**NOVA-DETECTOR\_PROTOTYPE**  
**IPND PVC MODULES**  
**16 CELL HORIZ. EXTRUSIONS GLUED**

SCALE	DRAWING NUMBER	SHEET	REV
1:8	3929.000-MD-444815	1 OF 1	A

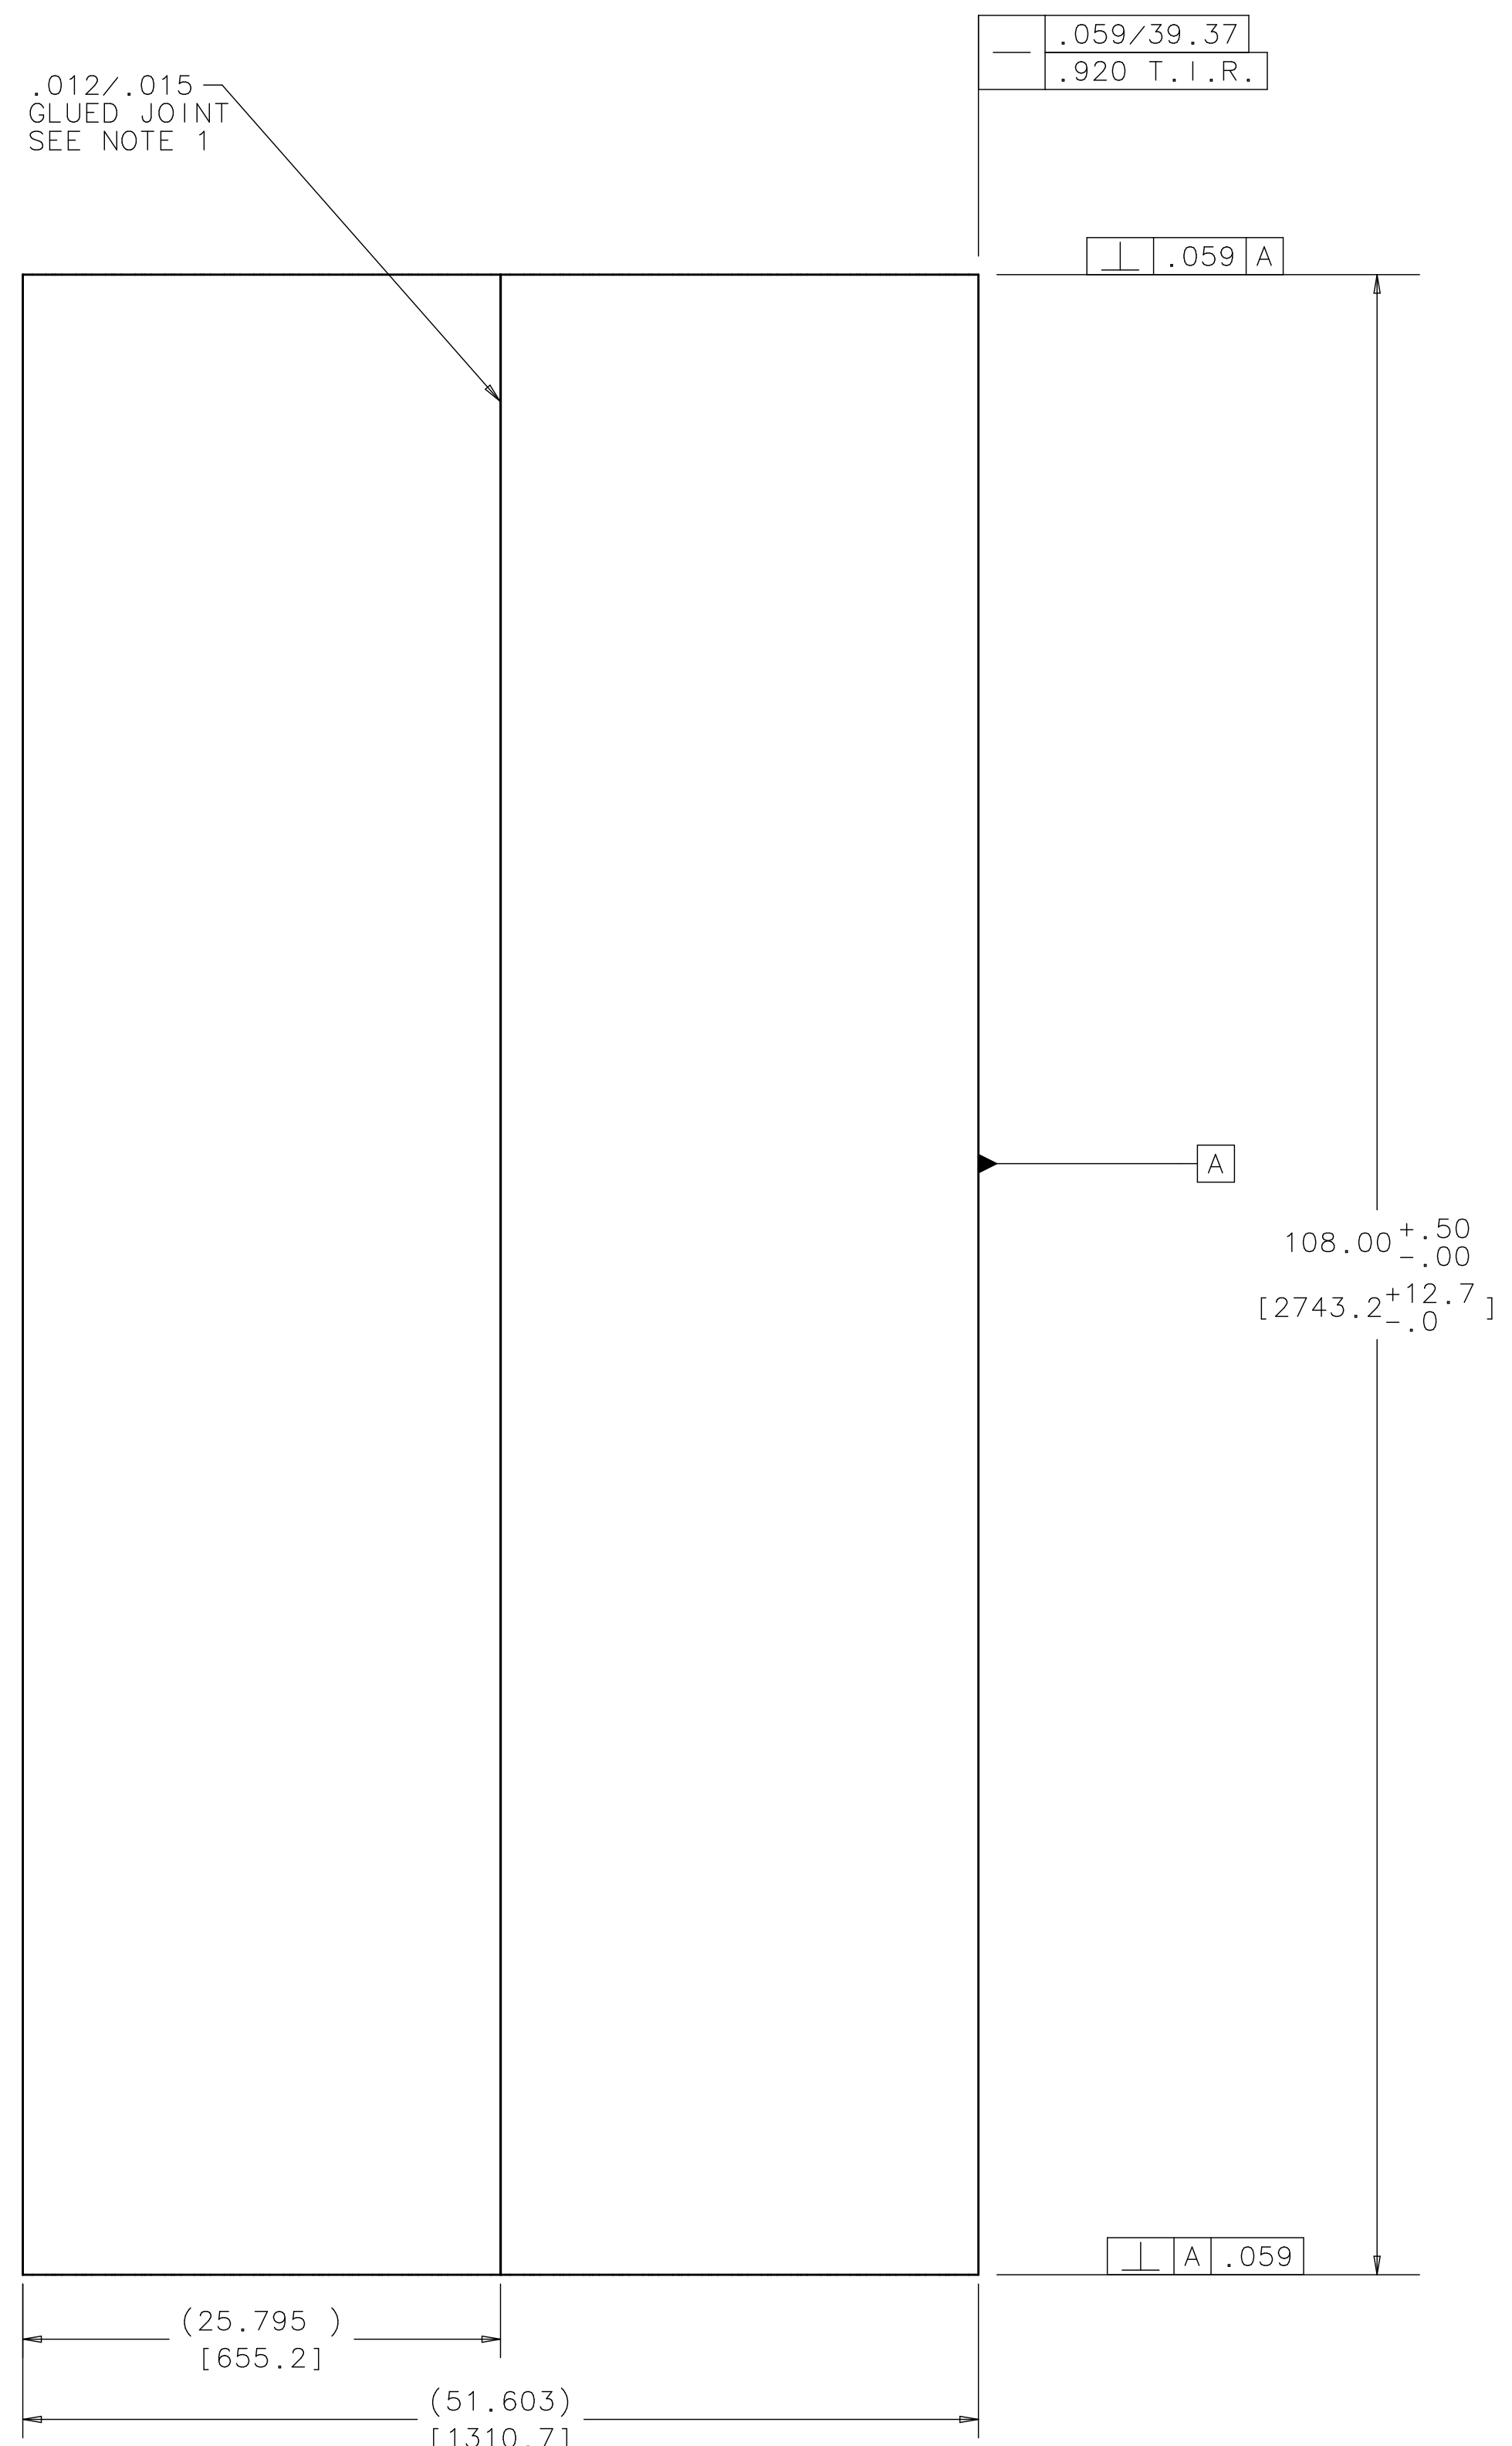
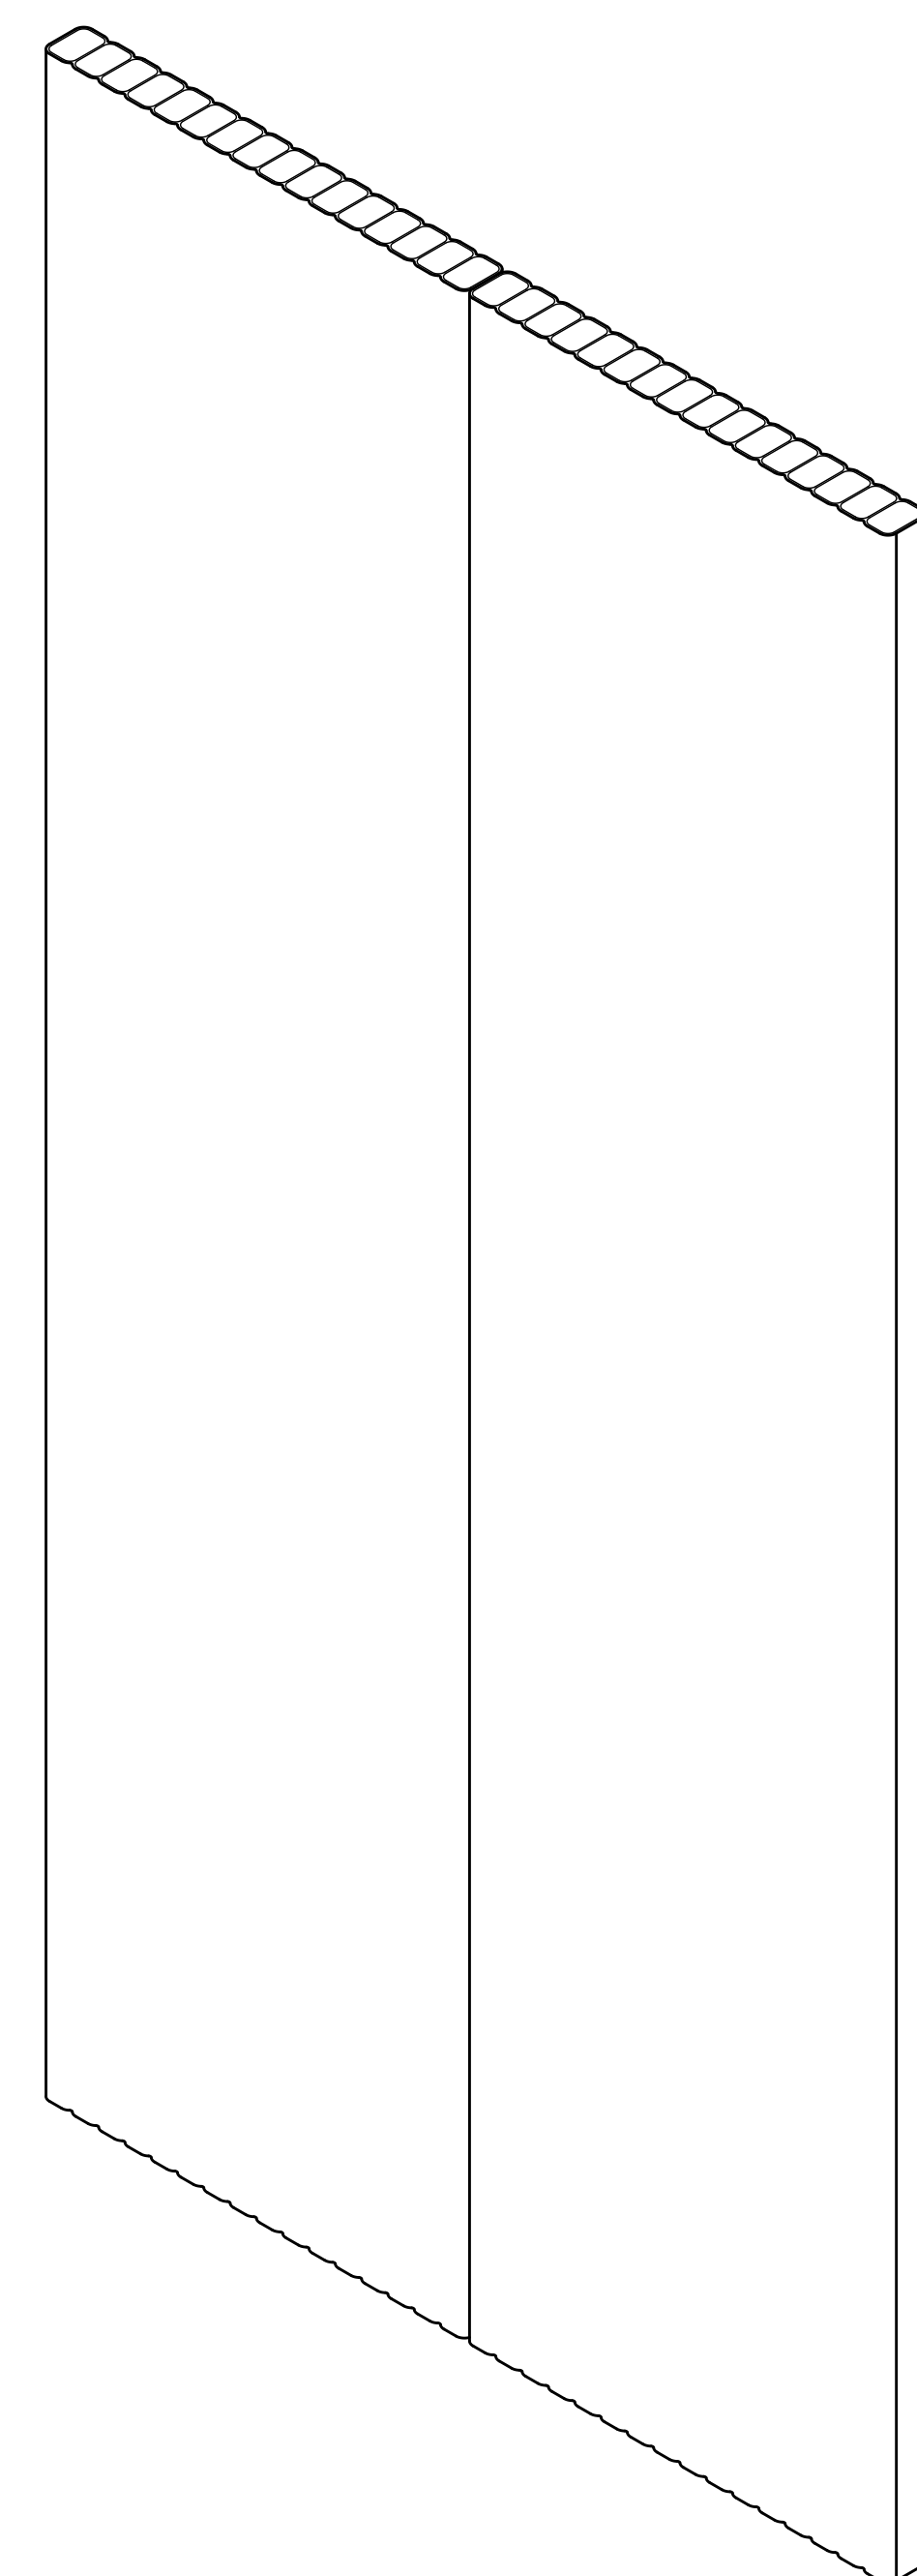
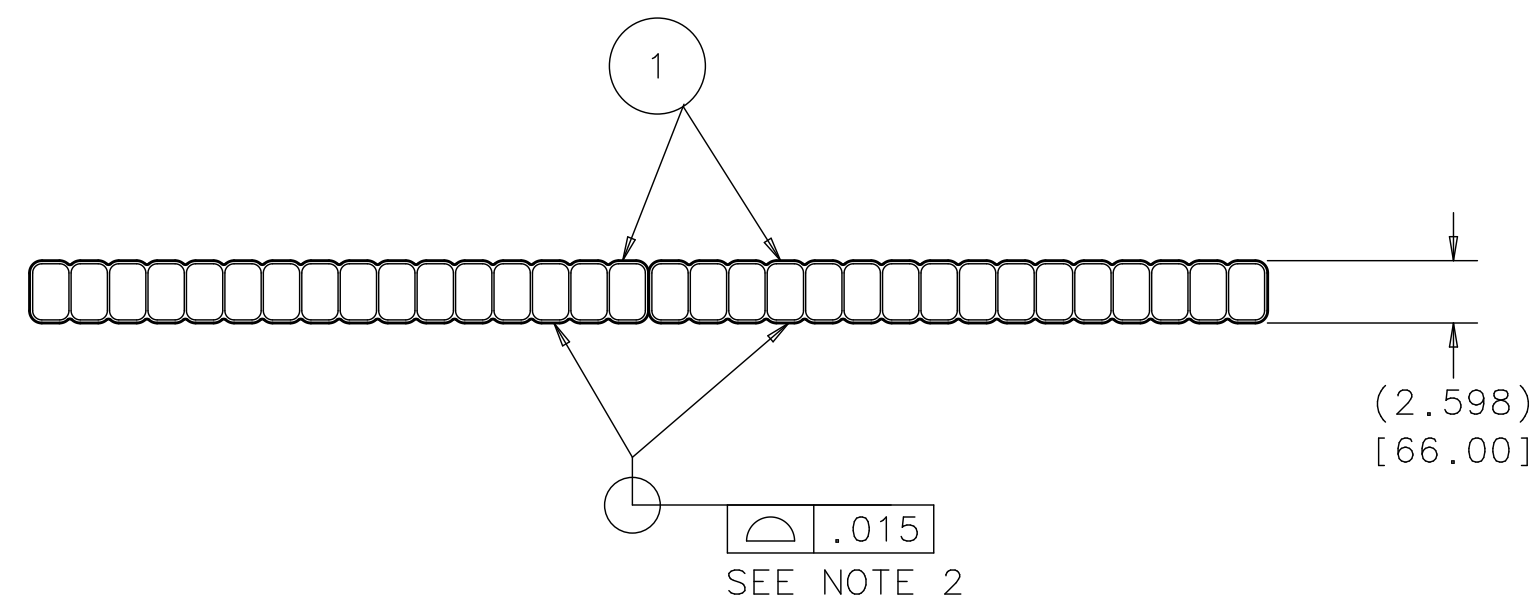
REV	DESCRIPTION	DRAWN	DATE
A	CHG'D NOTE 3 WEIGHT FROM 84 LBS TO 124 LBS.	D. FRIEND	02-SEP-2009
		GARY W. SMITH	08-OCT-2009

- NOTES:
- DEVCON PLASTIC WELDER 60 WELDER
  - PROFILE CRITERION WILL NECESSITATE SELECTING EXTRUSION THICKNESS (2.598") WITHIN THE ALLOWED TOLERANCE OF .015"
  - ESTIMATED WEIGHT IS 124 LBS.
